April 2021 Product Shipping Configuration Change Notice

Engineering Advisory 210949

April 2021 | 3725-47158-002

Poly VVX D230 with CN = MAC certificate should have the following on its product label:

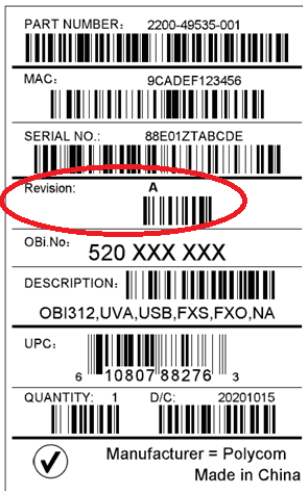
Note: All VVX D230 with MAC Address starting from **9CADEFA8503B** onwards and manufacturing date from **May 2020** have CN = MAC certificate.
